SB0114

SERVICE BULLETIN

Affected Equipment: YPAL MOD A, B, C, and D units

Subject: Rain Water Accumulation in the Unit Top Panel

FIGURE 1

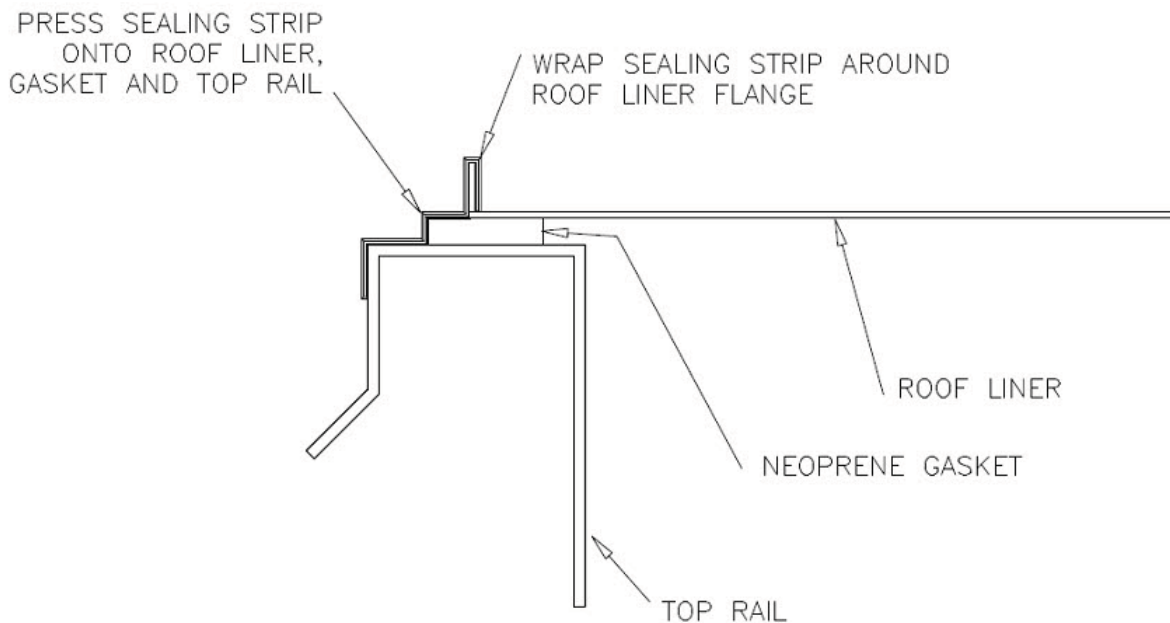
12. Apply the sealing strip, as shown in Figure 1 in one continuous length around the perimeter of the unit. When required overlap any joint with a 1 inch overlap.
13. Install replacement insulation making sure the insulation does not extend beyond the outer flange of the top panel inner liner. Make sure the top panel inner liners and center channels are covered by insulation.
14. Reinstall the top panel section starting at one end of the unit and installing one panel at a time. Use the screws removed in step 4 to fasten the top panel to the unit top rail.
15. Apply a continuous strip of double sided tape where two top panel sections butt together. Start at the drip flange on one side of the top rail and run the tape across the top panel and down to the drip edge of the top panel on the other side. Center the tape on the joint between the two panels. See figure 2.
